# SERVICE NOTICE

**RIDE: GRAVITRON, STARSHIP ALIEN ABDUCTION  
AND CENTRIFUGE**

**SUBJECT: TRAP DOOR MICROSWITCH  
INSTALLATION**

7W03001

TRAP DOOR MICROSWITCH INSTALLATION

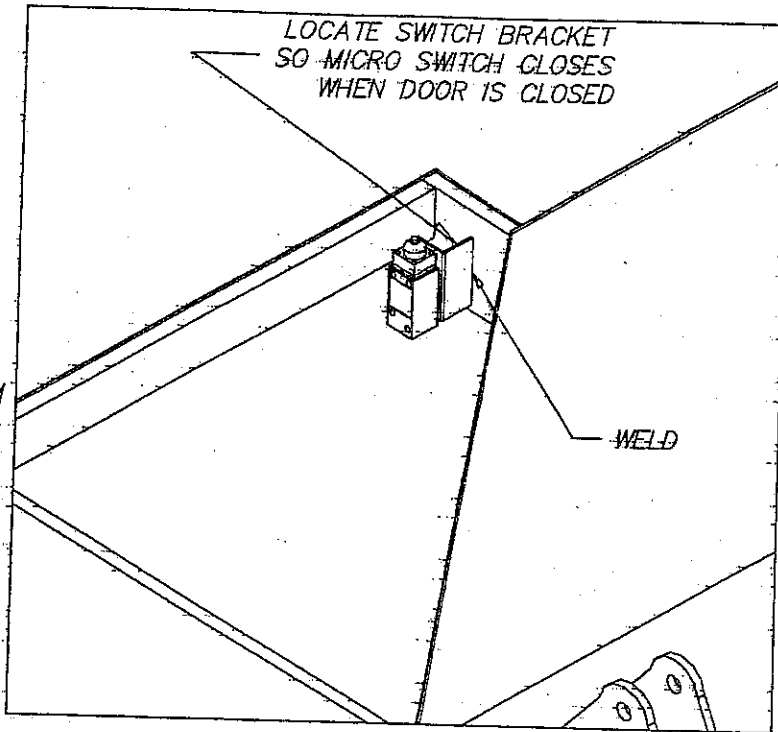
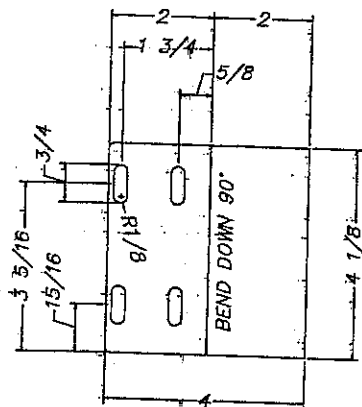
Due to the risk of employees being injured by standing in the trapdoor of the Gravitron/Starship/Alien/Centrifuge rides, it is required that the trapdoor be closed at all times. Some agencies require that the trapdoor be permanently closed by welding.

Some agencies require that the trapdoor be accessible as a second means of egress. If this is the case, attached is a system to interlock the trapdoor with the drive system so that when the door is open the drive system is disabled and the operator cannot energize the main motor with the trapdoor open.

One system or the other is required to be performed.

1. REMOVE WHITE WITH RED STRIPE FROM COMMUTATOR.
2. ATTACH TO ONE WIRE FROM MICROSWITCH.

3. ATTACH OTHER WIRE FROM MICROSWITCH TO THE RING THAT THE WHITE WITH RED STRIPE WAS CONNECTED TO.

4. WIRES ATTACH TO THE NORMALLY OPEN CONTACTS IN MICROSWITCH.

SWITCH INSTALLATION  
SHOWN WITH DOOR OPEN
